SERVICE BULLETIN

APPLICABILITY: 2013-14MY BRZ

NUMBER: 12-167-14

SUBJECT: Door Latch / Actuator Freezing

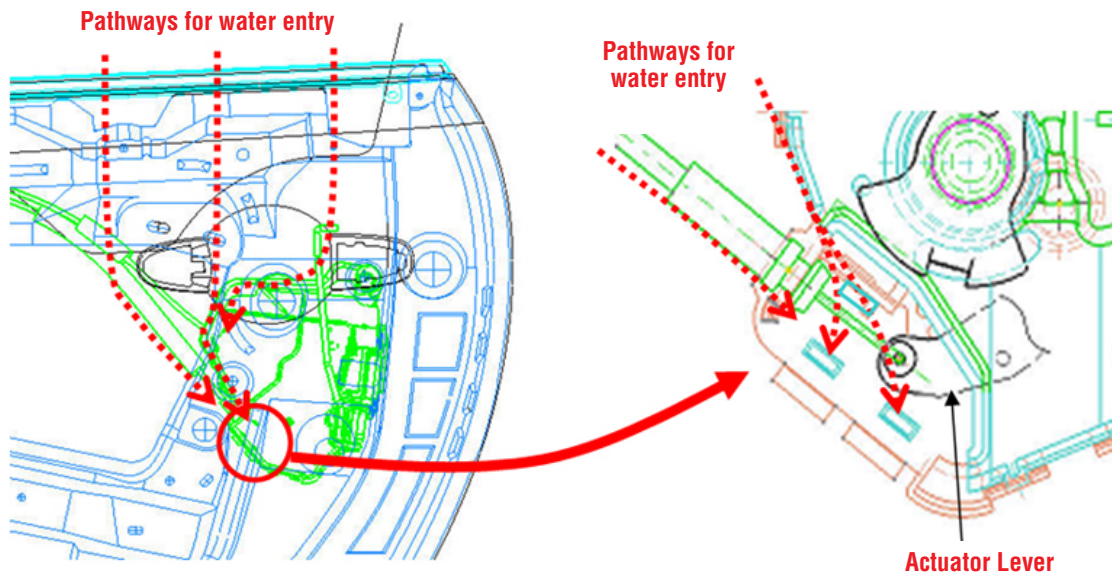
This bulletin provides a repair procedure to prevent water from accumulating then freezing inside the door latch / actuator assembly in cold temperatures and binding the mechanism. Application of a self-adhesive sealing tape to cover the water entry points will reduce the possibility of this condition occurring.

The illustrations below show the different pathways water can travel to enter the latch / actuator.

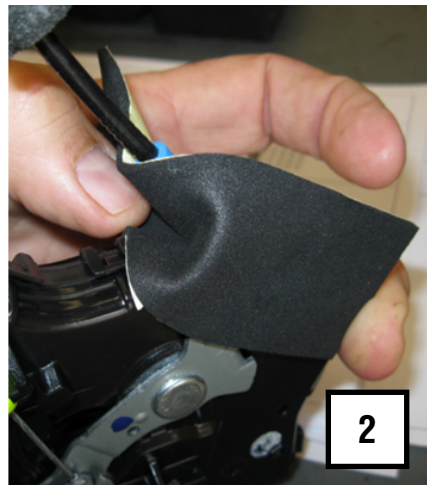
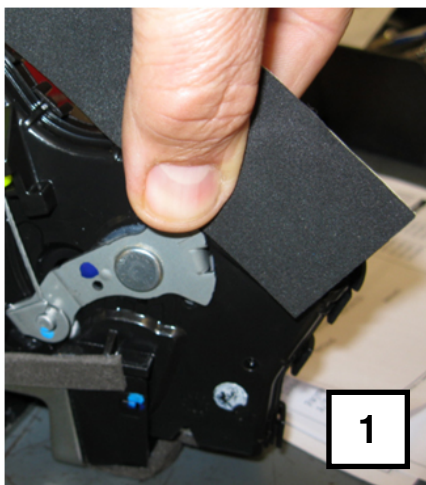
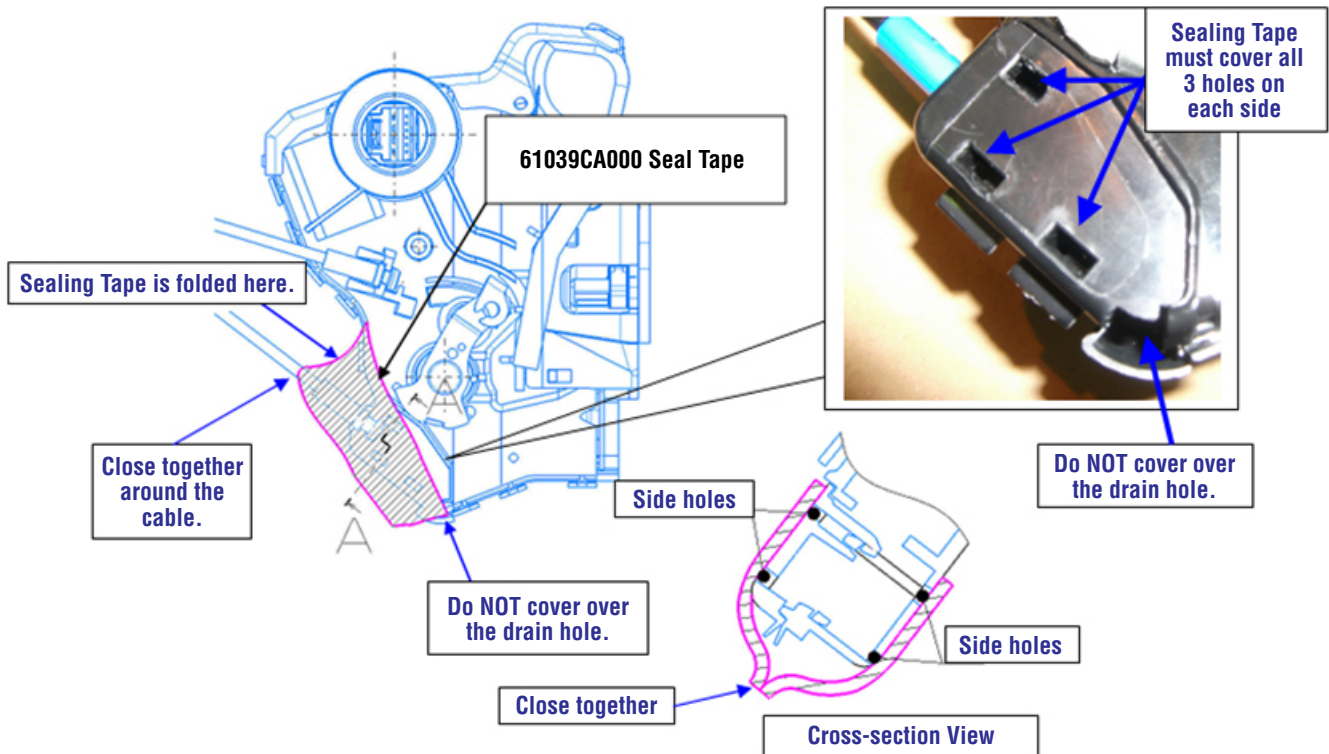
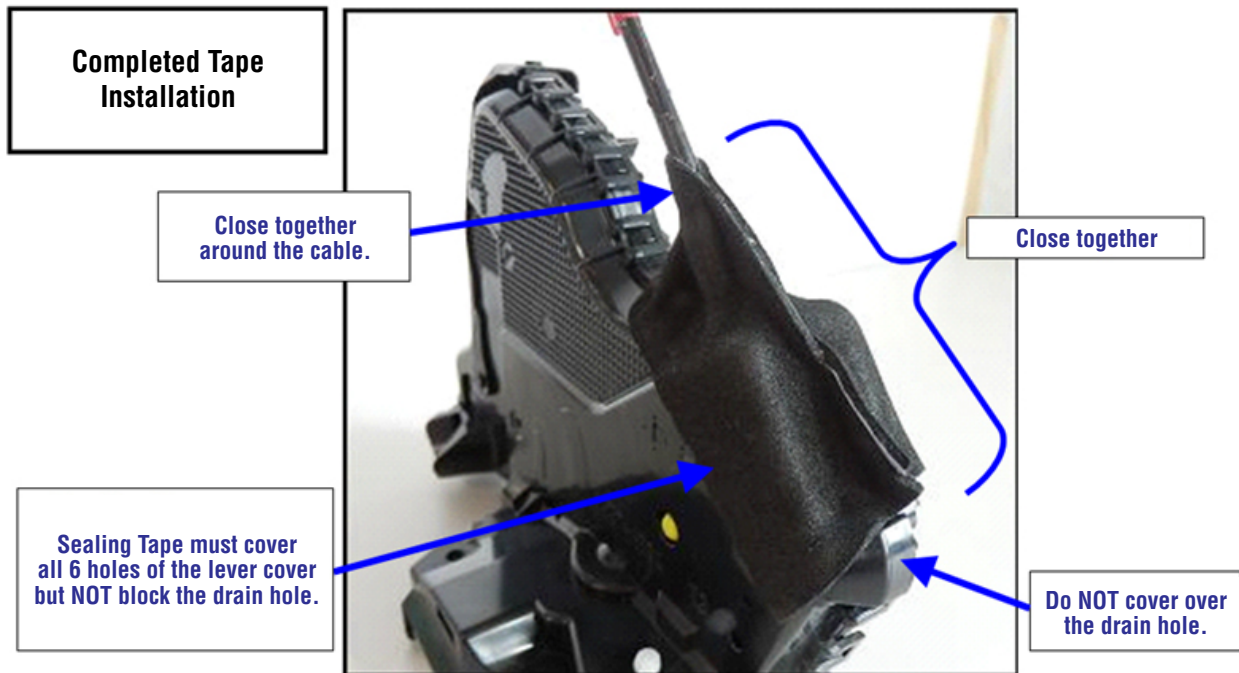
IMPORTANT: Review the illustrations below for proper application of the sealing tape. A “dry run” with the sealing tape is recommended before peeling the adhesive backing to prevent improper installation.

The illustrations and step-by-step photos below are provided as a reference for how the sealing tape needs to be applied to the latch / actuator assembly. The term “close together” refers to areas where the sealing tape material is adhered to itself to form a “seal”.

NOTE: In the event a latch / actuator assembly is being replaced and the replacement part does not have the sealing tape, it must be applied before installation.
